Waste Permits Division Correspondence Cover Sheet

Facility Name: Beck Landfill

Permit or Registration No.: 1848A

MUNICIPAL SOLID WASTE PERMIT MAJOR AMENDMENT-3RD NOD RESPONSE

D3.2 Final Cover Tie-In Detail

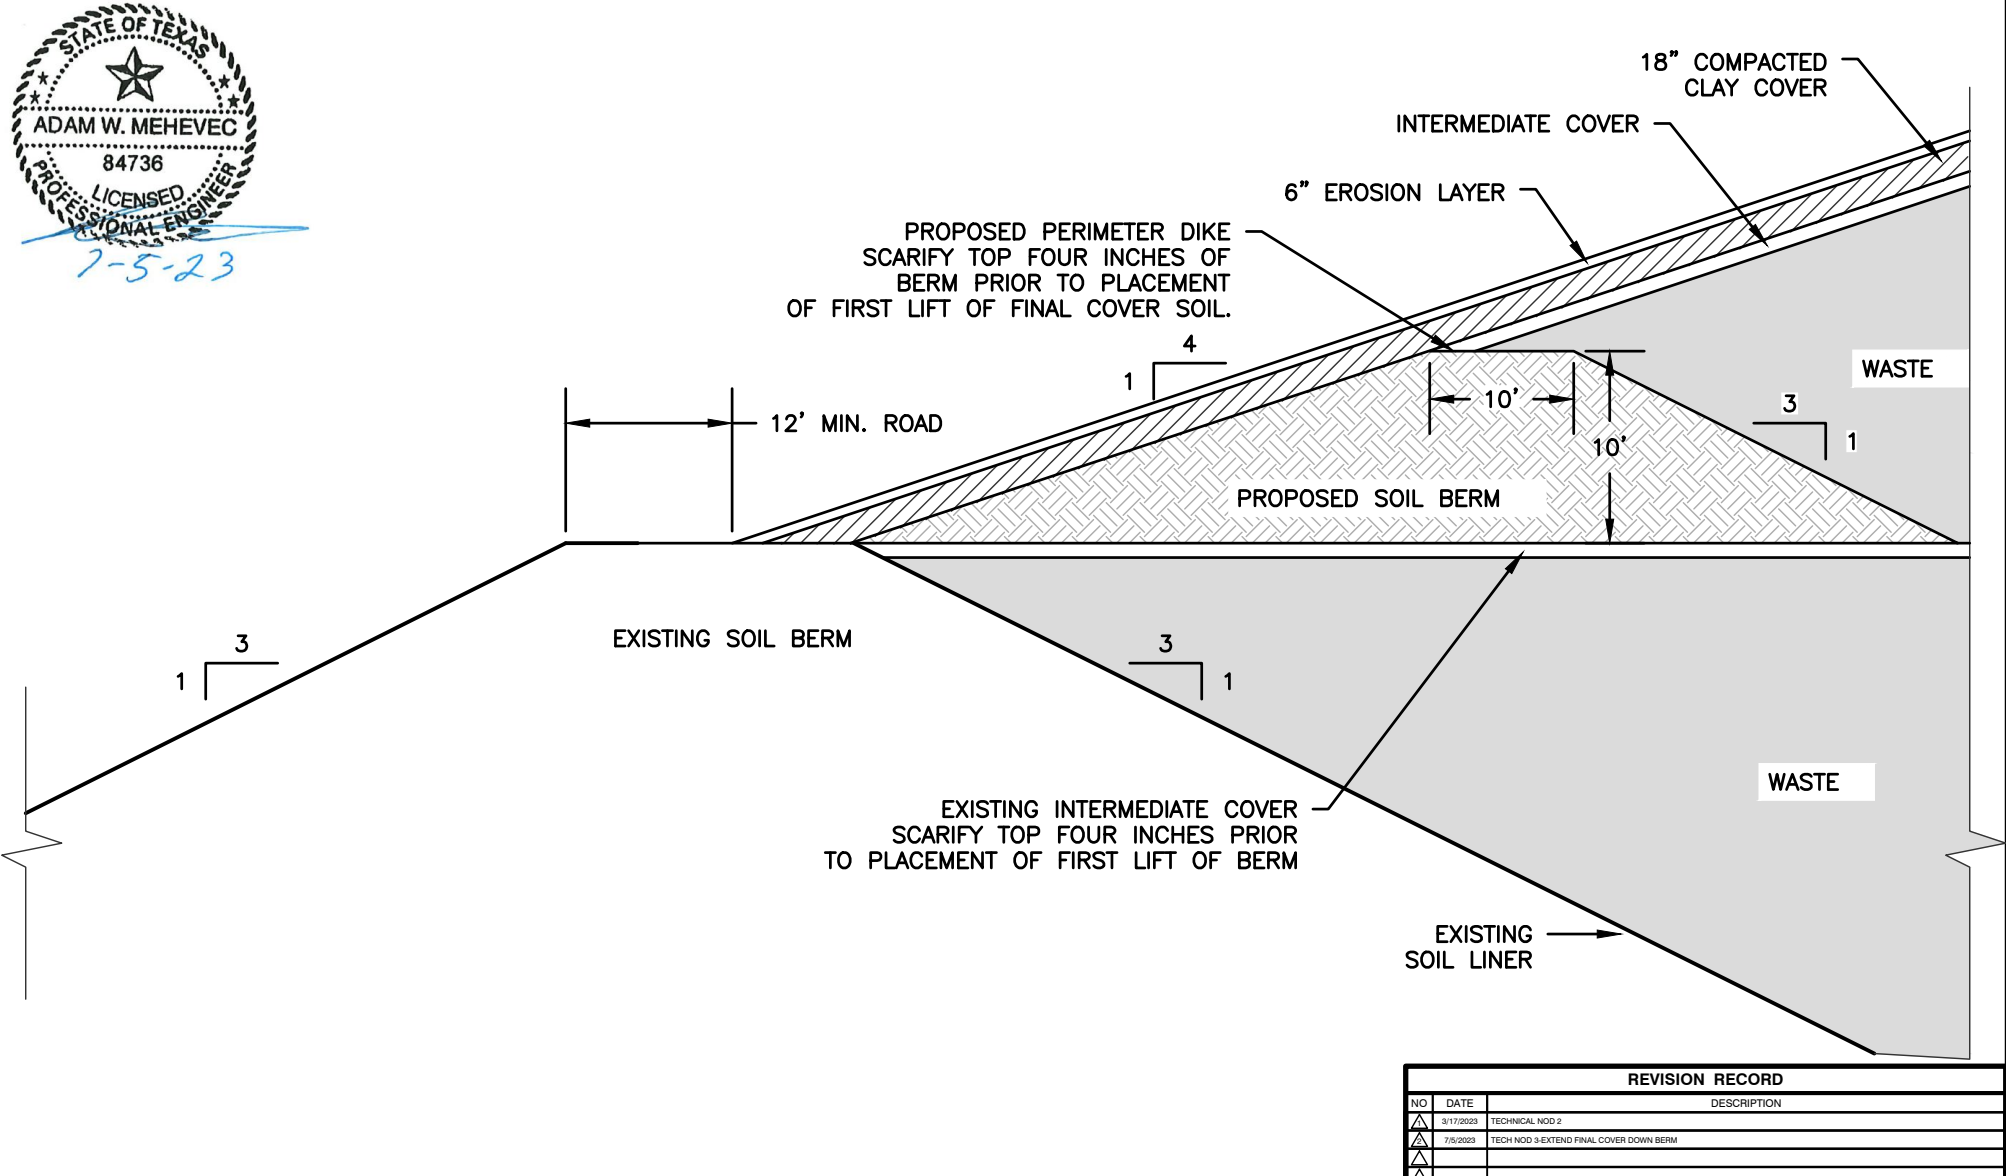
| NOD ID | MRI ID | App. Part | Citation | Location | NOD Description | Response |
|--------|--------|-----------|-----------------|---------------|---|--|
| 19 | 356 | Part III | 330.63(d)(4)(F) | Attachment D3 | Extend final cover to the perimeter of the below-grade waste. | Figure D3.2 has been revised to show the final cover covering the proposed soil berm and extending beyond the lateral edge of the below-grade waste. |

FIGURE E-4 QUATERNARY FAULT MAP

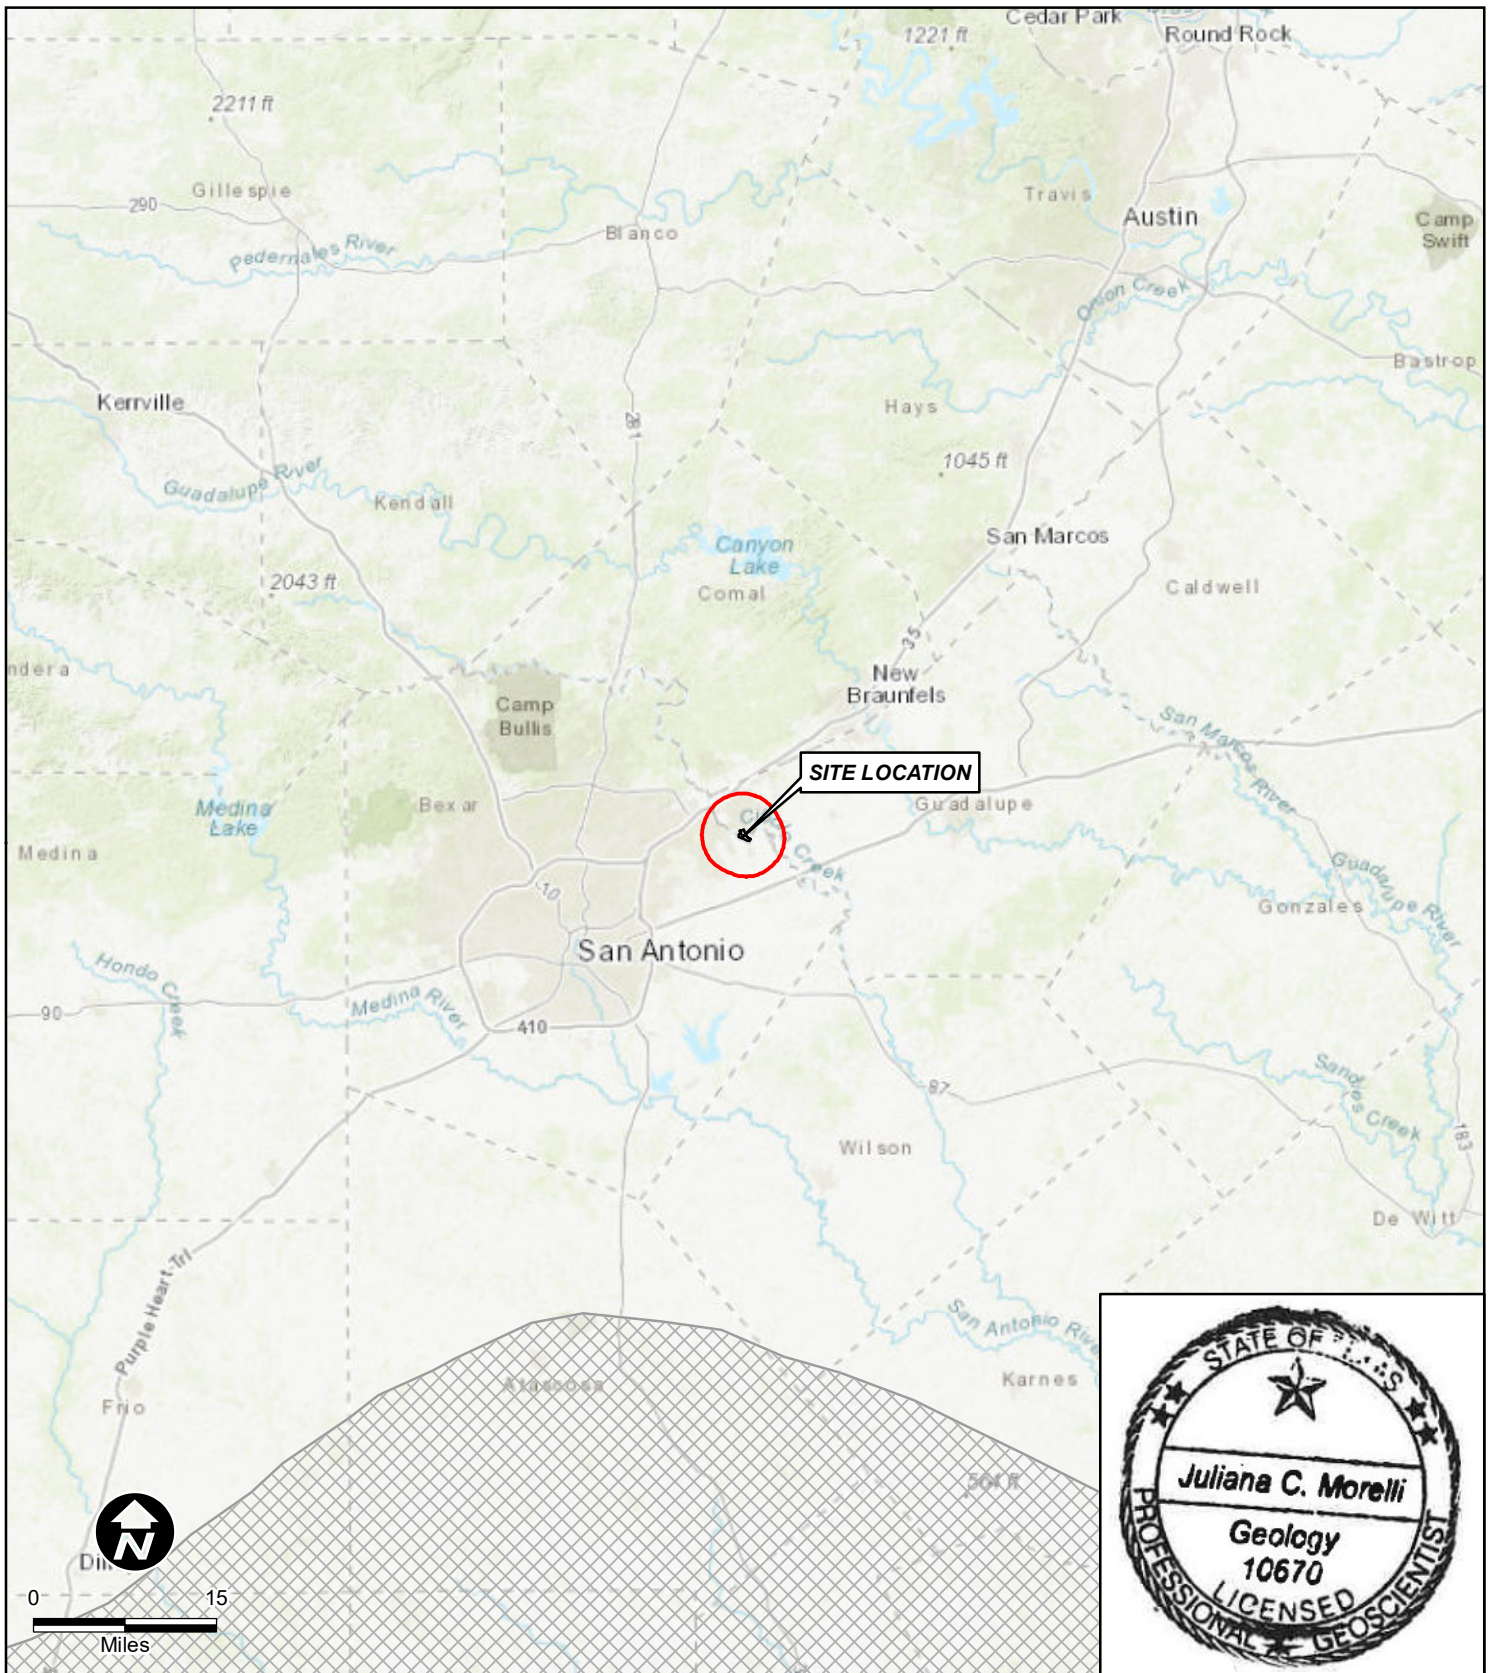
| NOD ID | MRI ID | App. Part | Citation | Location | NOD Description | Response |
|--------|--------|-----------|-----------------|-----------------------------|---|---|
| 23 | 474 | Part III | 330.63(e)(2) | Attachment E | Use the version of Figure 3-4 in the response to the first NOD, with the facility location marked, the size of the legend increased for legibility, and the source URL for the map indicated. | Use version from first NOD and included new version. See Figures E-4 and E-9. |

FIGURE E-8 SEISMIC IMPACT

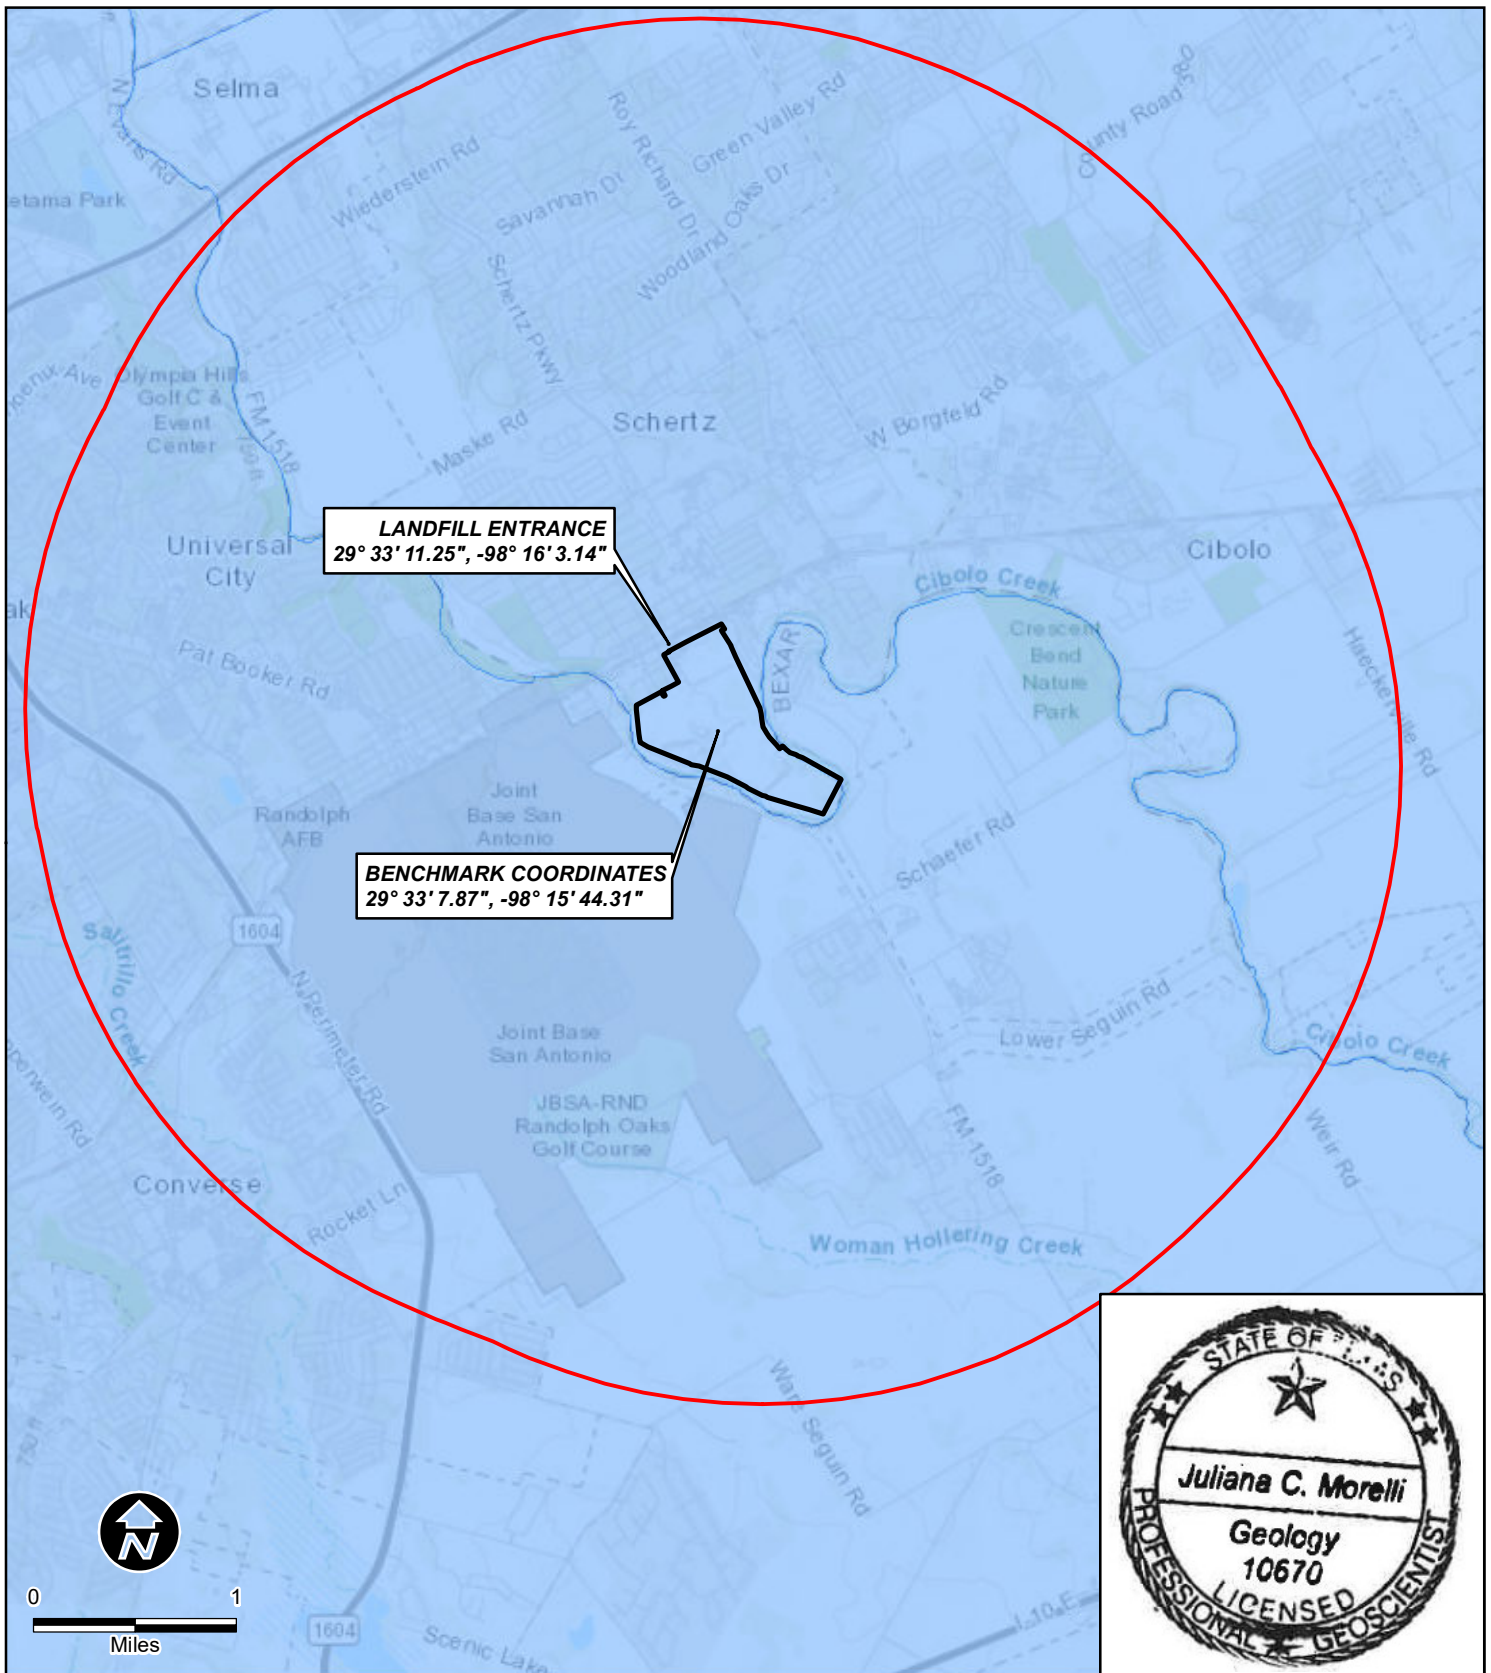
| NOD ID | MRI ID | App. Part | Citation | Location | NOD Description | Response |
|--------|--------|-----------|-------------------------------|-----------------------------|---|--|
| 7 | 148 | Part II | 330.61(j)(3) | Part II, Attachment G | Provide larger-scale seismic impact zone map in Part II, Attachment G, and in Part III, Attachment E, showing landfill location. Spell out the complete internet source address (URL) in the caption to the drawing. | Figures E-8 and E-9 are provided in Part III, Attachment E to address this comment. Figure E-8 has also been included in Part II, Attachment G. |
